I have had numerous inquiries regarding this modification. The inability to turn off the internal software timer that limits reception while in crossband and skycommand modes can be defeated by this minor modification. The reset pulse that it provides is of such a short duration that it is difficult to detect unless you are specifically watching for it to occur.

This circuit resets the internal software timer when in crossband repeat or skycommand modes by breaking the ground connection of the Main Band squelch control for a few milliseconds about every 2.75 minutes. . The change shown to the PC board and associated schematic will overcome the limit on reception of signals on the Main Band.

X57-605X-XX(C/9)

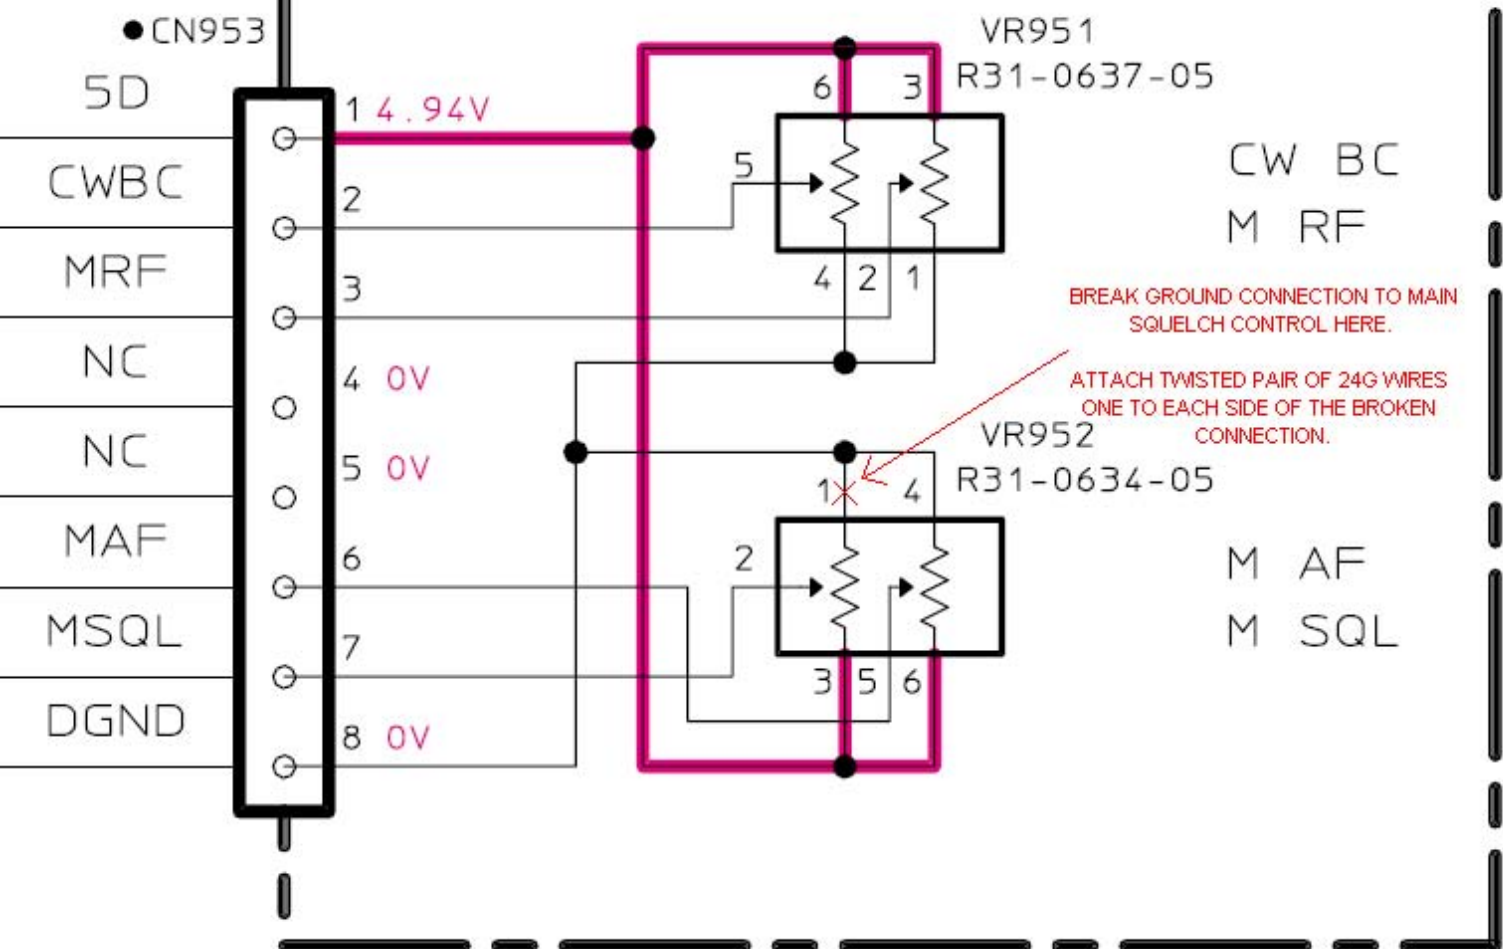
REMOVE VR952 FROM PCB AND CUT
THE COPPER TRACE THAT CONNECTS
THE MAIN SQUELCH CONTROL TO THE
GROUND PLANE AT THE THREE PLACES
SHOWN IN RED BELOW

MOUNT AND SOLDER VR952 ON THE PCB
ATTACH TWISTED PAIR OF 24G WIRES
ONE TO THE GROUND PIN OF THE MAIN
SQUELCH CONTROL AND THE OTHER TO
THE COPPER GROUND PLANE OF THE PCB

THREE
TRACE
CUTS
